Parts Technical Information

Volume J6
Number J1
DATE MARCH 1985

SUBJECT FUEL TANK ELEMENTS

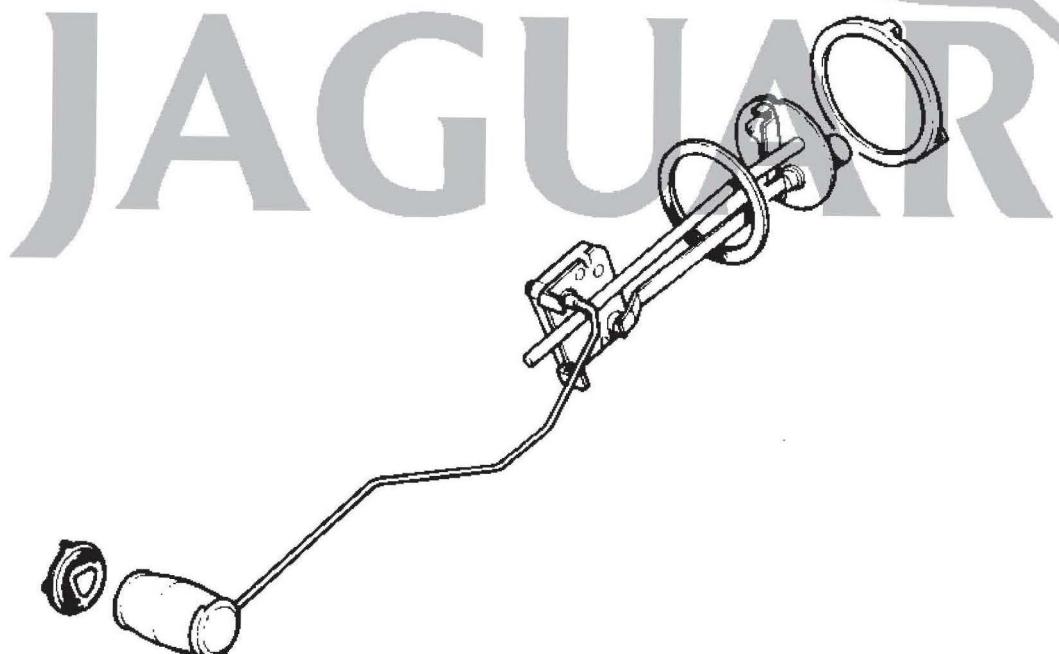
When ordering fuel tanker elements CAC2800 & 1, C27738 & 9, it will also be necessary to supply the Locking Ring ARA1501 & Sealing Washer ARA1502. These two components are not part of the element assy.

SAC SUBJECT WATER PUMP

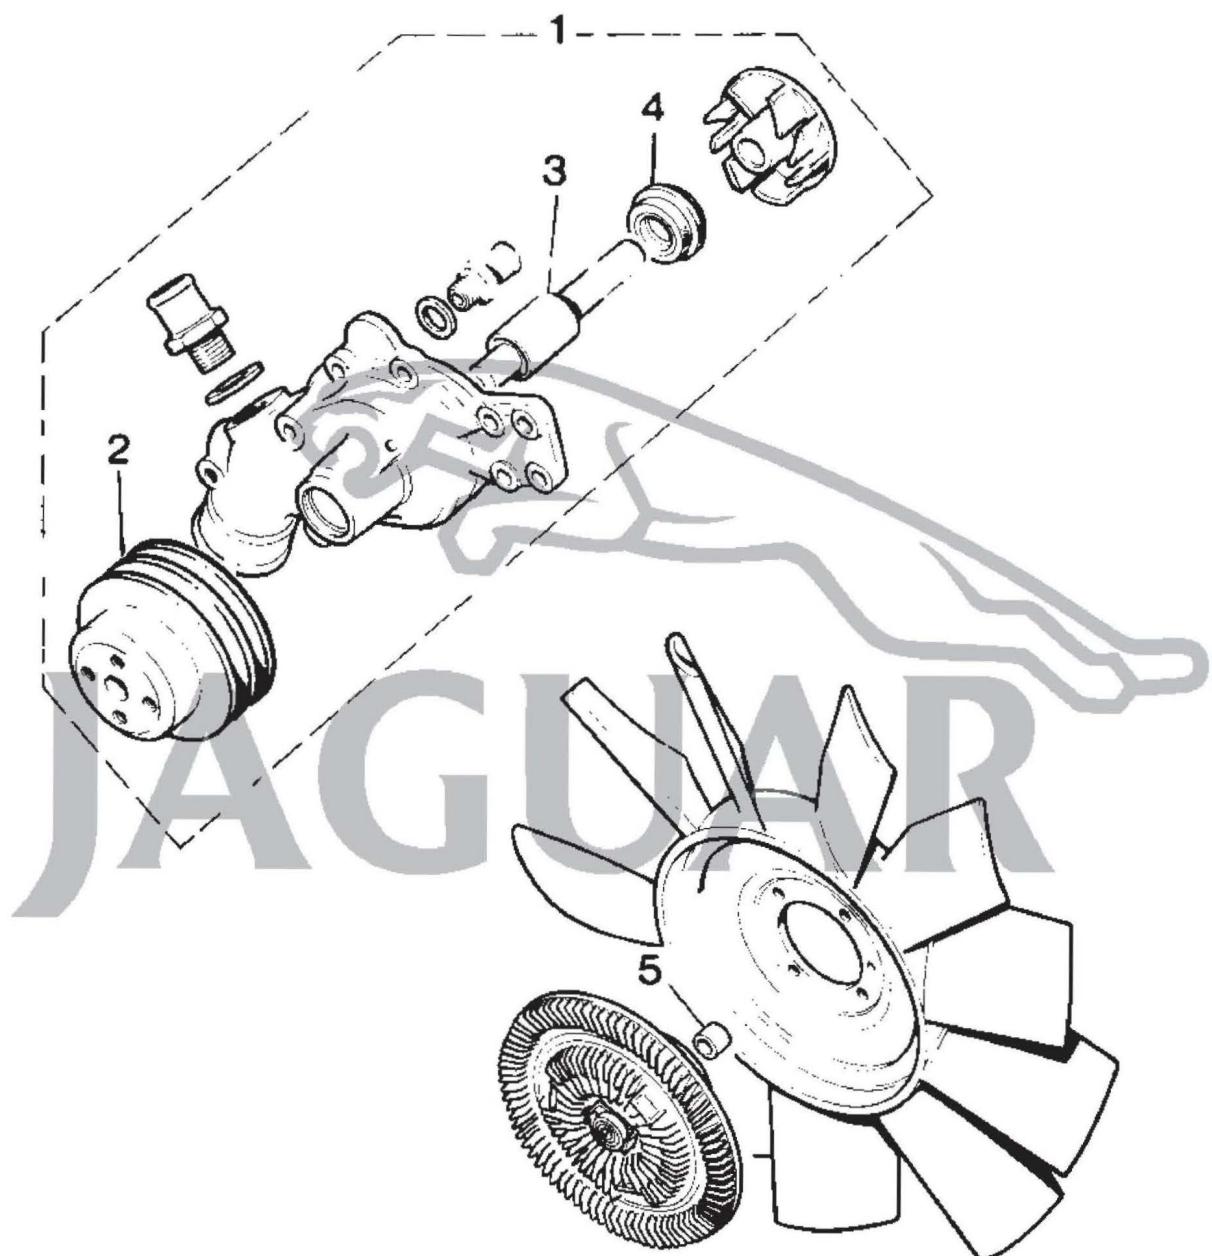
From Engine Nos 8L179779(XJ6 4.2 Litre);8A15831(XJ6 3.4 Litre) and 7M5019(Limousine) a new Water Pump Assembly with larger diameter Bearing and improved Sealing has been introduced. The constituent details are not interchangeable, but JLM206 and EAC6860 Water Pumps can be used as replacements for JLM9699 and fitted.

New Part No	Qty	Description	Existing Part No	Remarks
JLM206	1	Water Pump Assy	JLM9699	XJ6
EAC6860	1	Water Pump Assy	EAC3661	Limousine
EAC6306	1	Pulley	EAC3183	XJ6
EAC6861	1	Pulley	EAC3662	Limousine
EAC6305	1	Bearing	EAC3046	
EAC6447	1	Seal	C28089	
	-	Bush	EAC4382

SUBJECT - DOOR HANDLE GASKETS

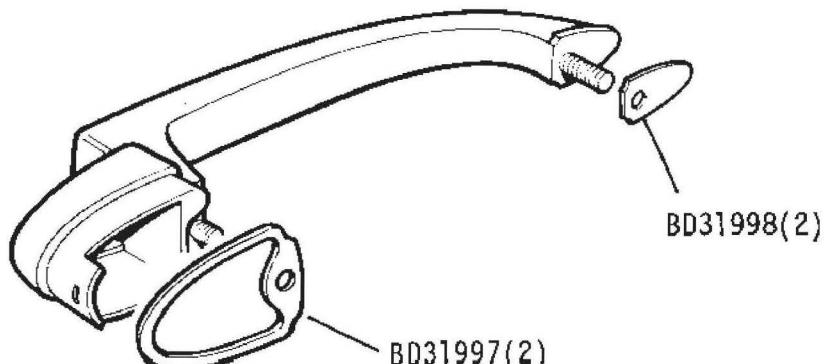
The door handle gaskets BD31997 & 9 have been transposed on the illustration. The correct locations are as follows.

BD31997 - Gasket, front of handle
BD31998 - Gasket, rear of handle

Fig 1 - Rear Lens and Trim Infill

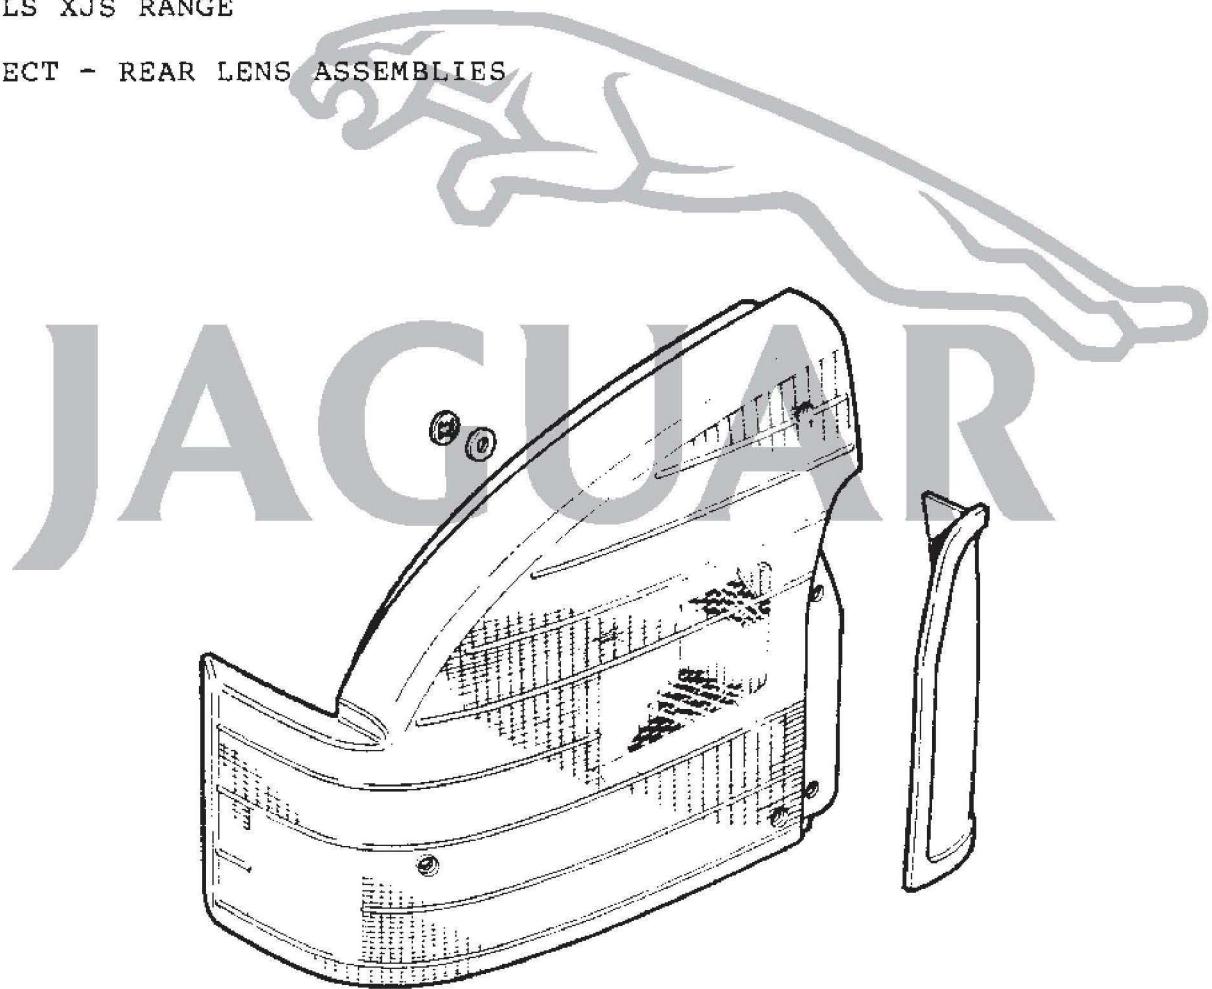
Supplies of the original type rear lens assemblies are no longer available. To ensure interchangeability, the lens will now be supplied minus the trim infill which can be ordered as a kit (contains RH & LH infills).

New Part No	Qty	Description	Existing Part No	Remarks
JLM1551	1	Lens Unit - RH	RTC1206 AEU2495 AEU2556	Not USA/CDN " "
JLM1552	1	Lens Unit - LH	RTC1207 AEU2494 AEU2555	Not USA/CDN " "
JLM1553	1	Lens Unit - RH	RTC1204 AEU1093 AEU2554	USA/CDN " "
JLM1554	1	Lens Unit - LH	RTC1205 AEU1095 AEU2553	USA/CDN " "
JLM1548	1	Trim Infill Kit	-	All Markets
JLM1549	1	Trim Infill RH	-	"
JLM1550	1	Trim Infill LH	-	"

SUBJECT Oil Filter Element

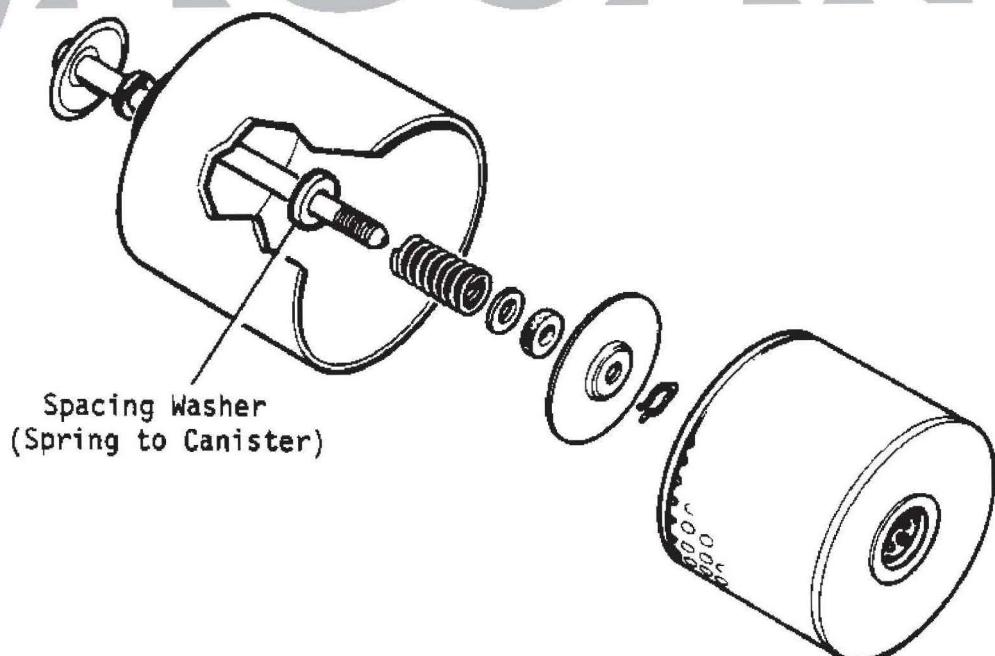
REASON FOR CHANGE The replacement oil filter element, JLM9546 has been found to be 1/8" under dimension. To compensate for this shortfall a plain washer, WA600071/J must be fitted between the pressure spring and the oil filter canister.
(See illustration below.)

Part No.	Qty	Description
JLM9546	1	Oil Filter Element
WA600071/J	1	Plain Washer

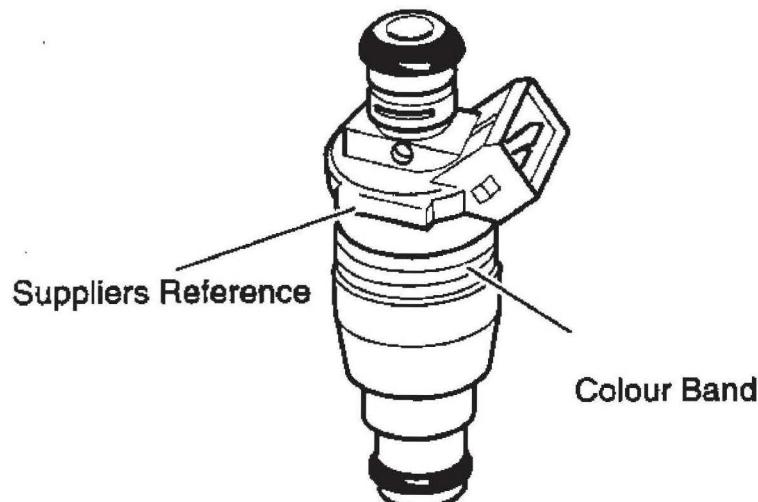
Once removed from the packaging these Injectors can only be identified using the supplier reference stamped on the side of the part. See below for details:

Part No.	Production Ident. Colour	Service Ident. Colour	Supplier Prod. Ref.	Supplier Service Ref.
DBC 10423	White	Green	D 3156KA	D 3156AA
DBC 11041	Red	Green	D 3165KA	D 3165AA
EBC 4430	Green	Green	D 3155KA	D 3155AA
